# SERVICE BULLETIN

Product : NF Monitor	Bulletin No. : 01-C/M-E0021
Model : S/M950NF.CPG19NF.S/M750NF. CPG17NF,CPG17NF	Bulletin Date : 10.May,2001 ECN Date : 10.May,2001
SUBJECT : Countermeasure for Display shift or size change of 17",19" NF model.

**A. Countermeasure for V-position shift**

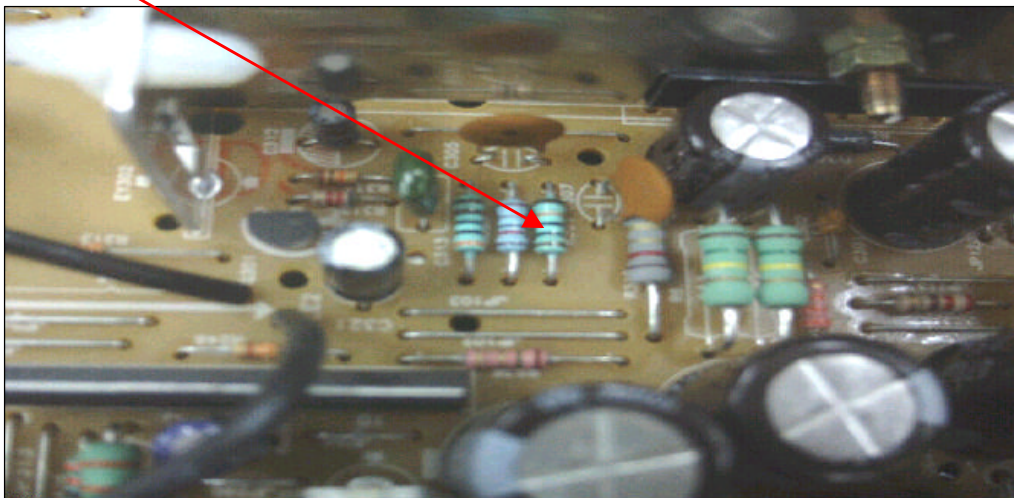
1. Add jump wire on back side of PCB

2. Replace R301

L/No	Before	Part Number	After	Part Number
R301	R-METAL 100K 1%	<b>2004-000193</b>	R-M,FILM 220K 1%	<b>2004-000560</b>

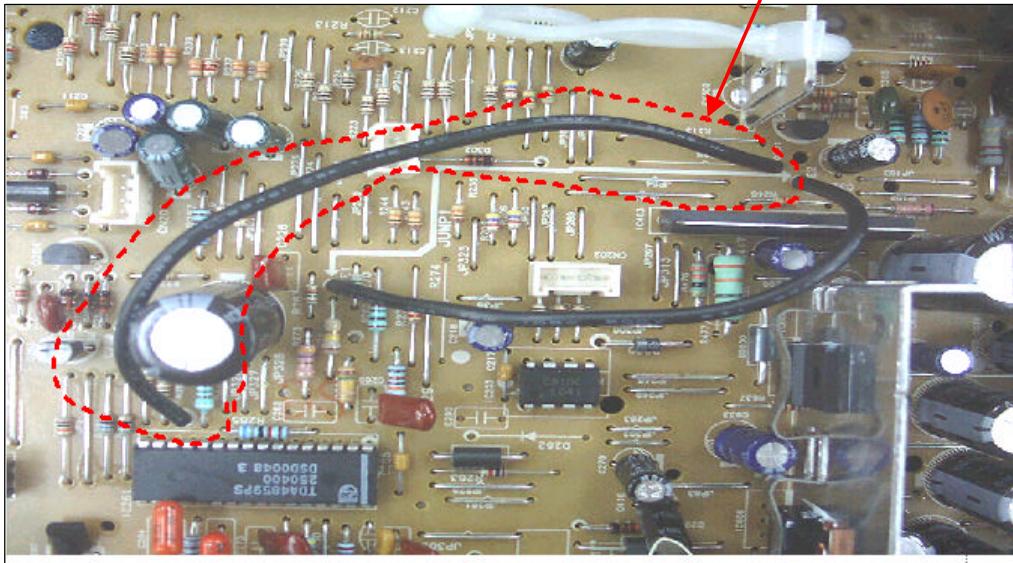
3. Remove jumper wire which connecting IC261 #13(Vref) and JP68

Remove

### B. Countermeasure for increasing H-size

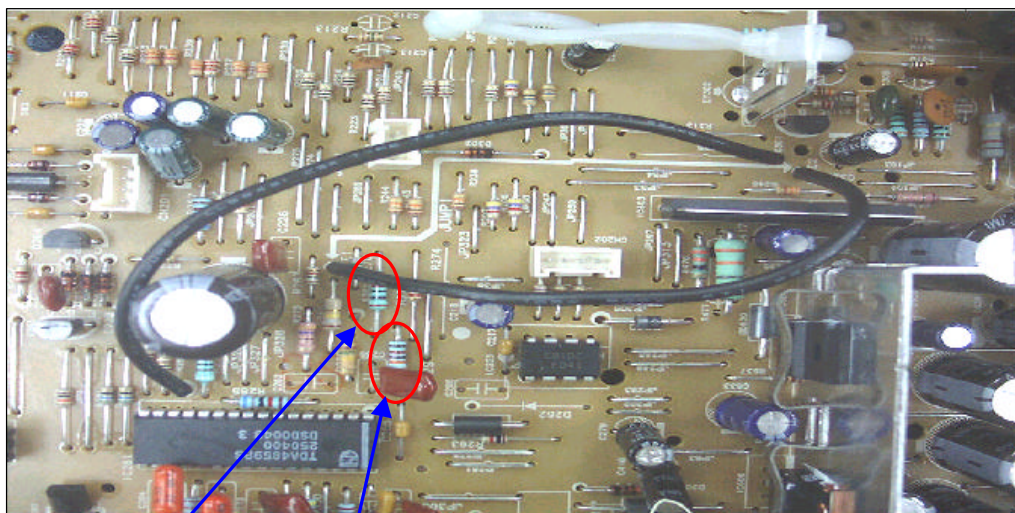
R286

R289

L/No	Before	Part Number	After	Part Number
R286	R-CARBON 180K 5%	<b>2001-000395</b>	R-METAL 180K1%,1/4W	<b>2004-000398</b>
R289	R-CARBON 150K 5%	<b>2001-000354</b>	R-METAL 150K 1%	<b>2004-000327</b>
